**ZONE CHANGE (RA-H TO PDR-4);
PDR STAGE I & STAGE II; AND
PRELIMINARY 3-LOT PARTITION
(2 PHASED); WITH
ZERO SETBACK WAIVER**

**Meridian United Church of Christ
(Frog Pond Church)**

Tax Lot 5500, Map T3SR1W 13AA

RE: Responses to Incomplete Application DB21-0029 through DB21-0033 – Meridian United Church of Christ (Frog Pond Church) - Zone Change with 3-Lot Partition; 6750 SW Boeckman Road (Tax Lot 5500, Map T3SR1W 13AA), Wilsonville, Clackamas County, Oregon.

A SECTION @ (E) COMMON WALL
 1" = 1'-0"

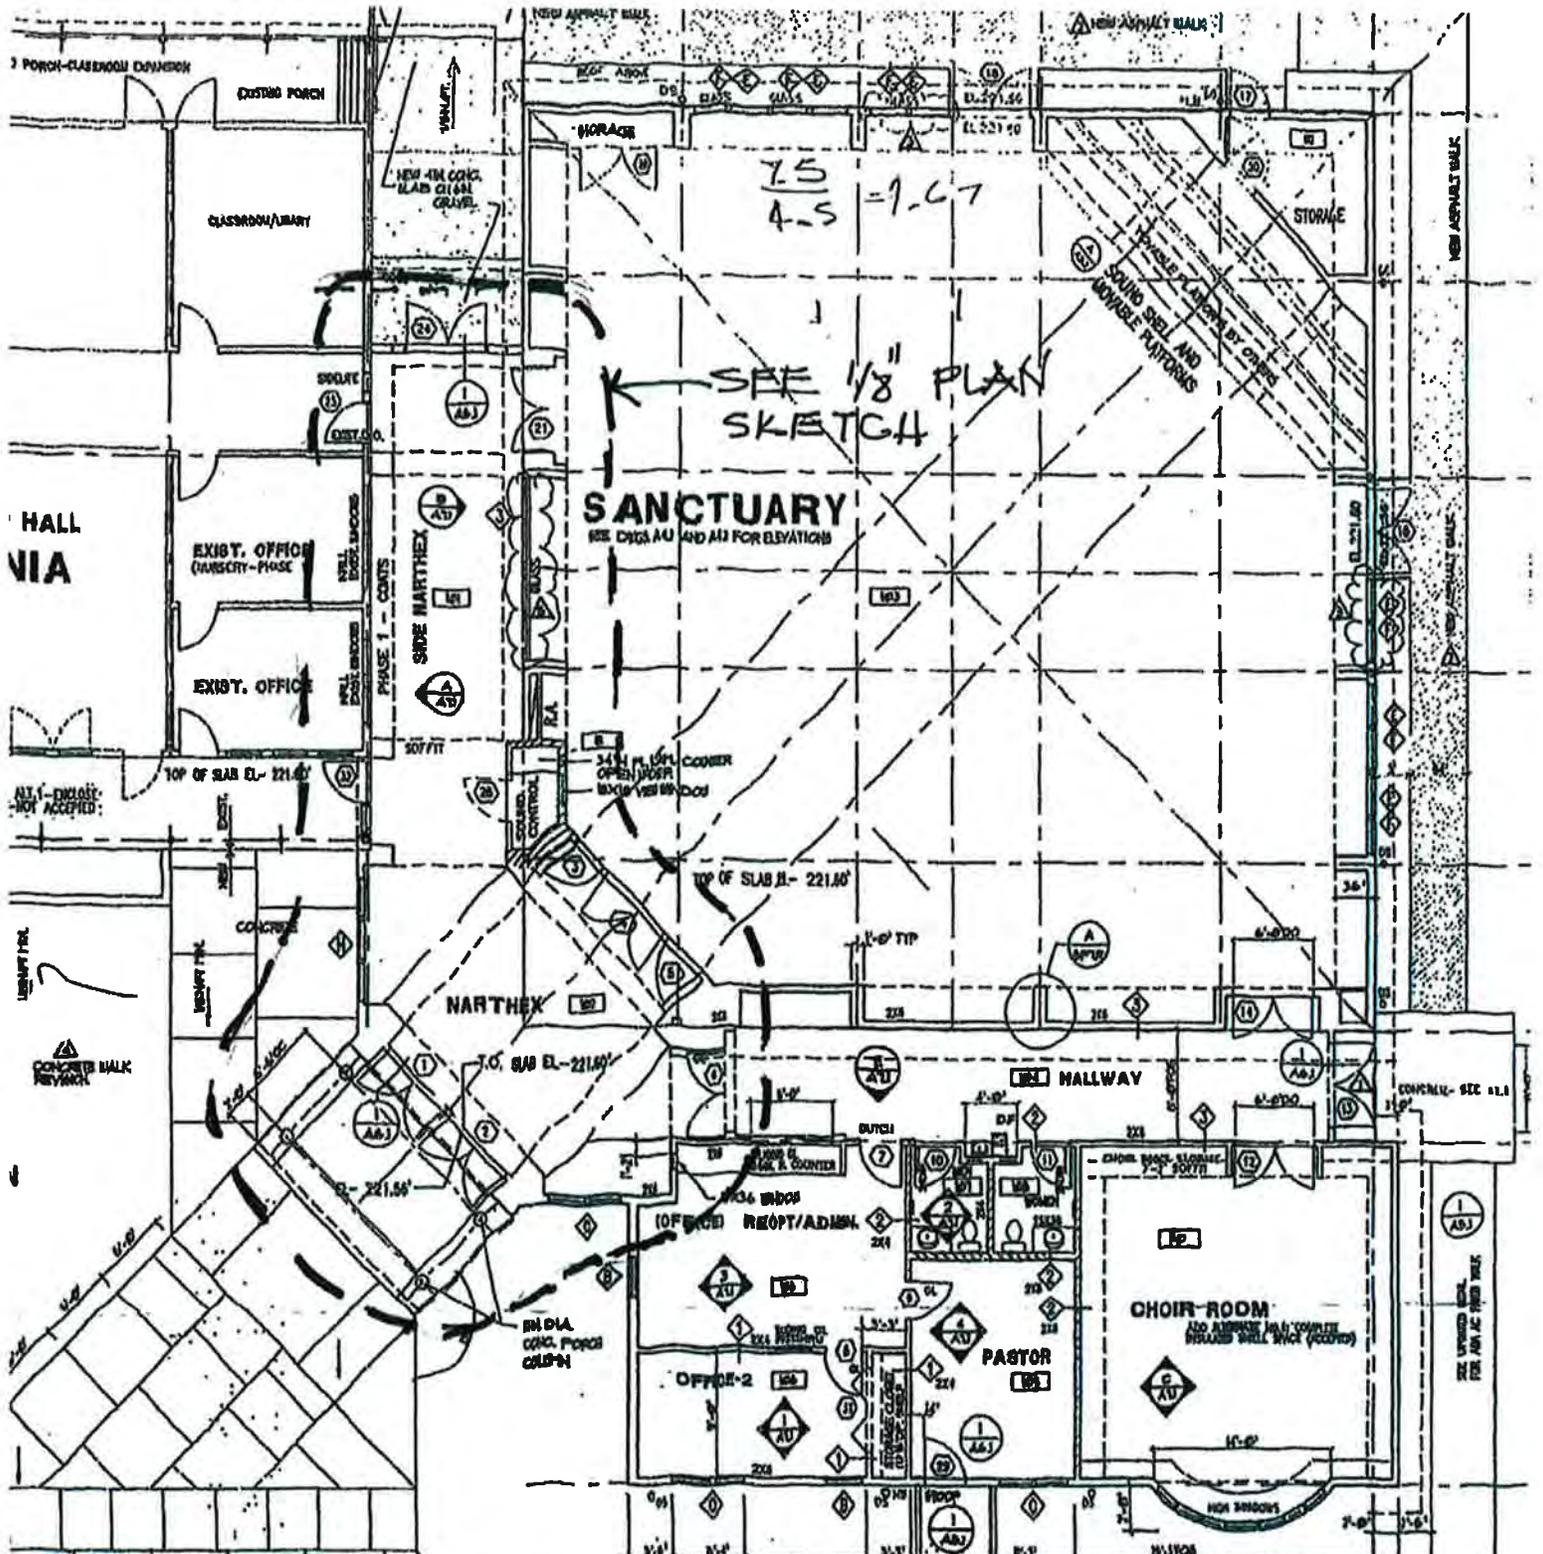
Section 706.8 Openings, Exception 1, states:
Openings are not permitted in party walls constructed in accordance with Section 706.1.1.
 - b. An access and maintenance easement agreement will be needed for the shared responsibilities of accessing and maintaining the common wall and roof/ceiling components that attach to it.
3. Engineering Items:
 - a. Show water meter for proposed Parcel 3 on plans
 - b. Show public easements across tracts on plans
4. Natural Resources Items:
 - a. A Stormwater Access Easement will be needed for the onsite stormwater system, including the proposed Tract B

RESPONSE: We apparently misunderstood the discussions with the Building Department. We thought we had agreement on the viability for the alternative method of providing a sprinkler curtain wall for the door.

However, given the strict interpretation of Section 706.1.1, we have revised the partition wall excluding the door, thereby providing for compliance with building code requirements for the “party wall.”
